Re: In the Matter of PORTLAND GENERAL ELECTRIC COMPANY,  
2019 Integrated Resource Plan  
**Docket No. LC 73**

In the Matter of )  
 )  
PORTLAND GENERAL ELECTRIC ) OPENING COMMENTS OF THE  
COMPANY, ) ALLIANCE OF WESTERN ENERGY  
 ) CONSUMERS  
 )  
2019 Integrated Resource Plan. )  
\_\_\_\_\_ )

**Comments of Dr. Marc M. Hellman on behalf of the  
 Alliance of Western Energy Consumers**

Re: LC 73 - Comments on behalf of AWEC on the 2019 Integrated Resource Plan of Portland General Electric Company

**Figure 2.5-1. Technology Maturity Model**

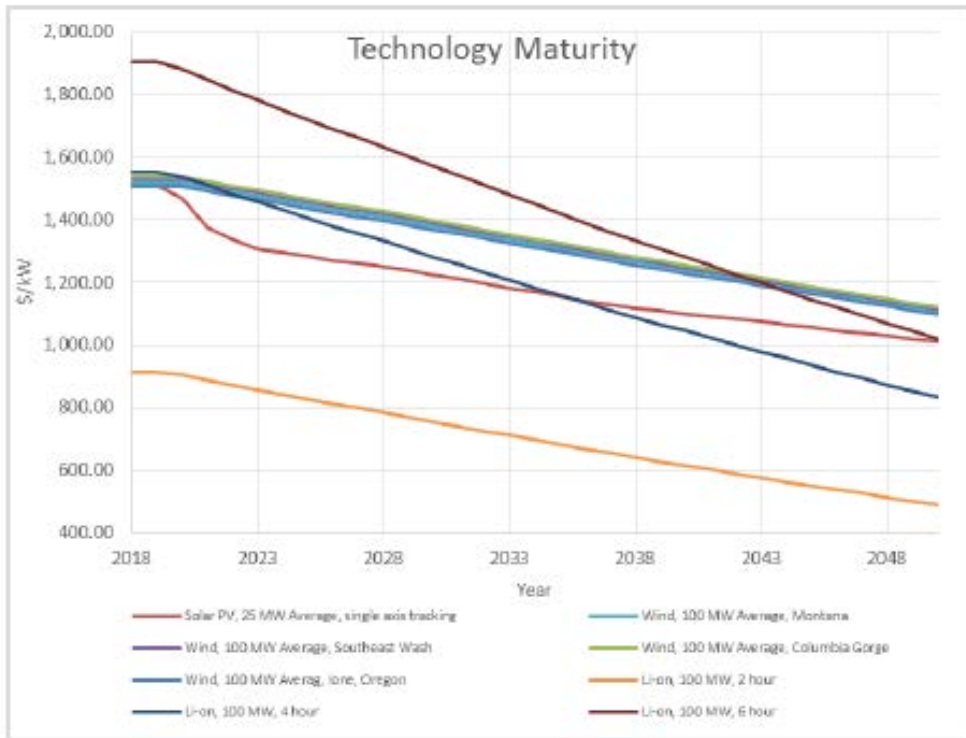
This can be seen from Figure 2.5-1 on Page 10 of the HDR Project on Renewables and Battery Supply Side Options. A change from \$1400/kW in 2028 to \$1200/kW in 2043 represents an annual one percent reduction in 2018 dollars cost per kW.

This cost reduction trend used by PGE can be more explicitly seen on page one of Appendix A-Technology Maturity/Cost Forecast. A portion of that table is presented below.

For example, the ratio of \$/kW expressed in 2018 dollars for 100 MW Columbia Gorge wind for the years 2021 to 2020 is 0.989 and rounds to 99 percent, or a reduction of one percent rate per year in the constant dollar installed cost of wind expressed in \$/kW .

PGE's assumption of a one percent decrease in the constant dollar installed cost of wind resources understates technological progress. Other sources reporting on wind economics, such as the 2018 USDOE Wind Technologies Report, provides data that shows technological progress to be much greater than 1 percent per year.<sup>3/</sup> And while installed cost per kW is meaningful, the ability to capture greater energy at the same or lower wind speeds also affects the technological progress. Therefore, in addition to considering changes in installed cost over time, expected MWH generation also needs to be analyzed to capture improvements in turbine design.
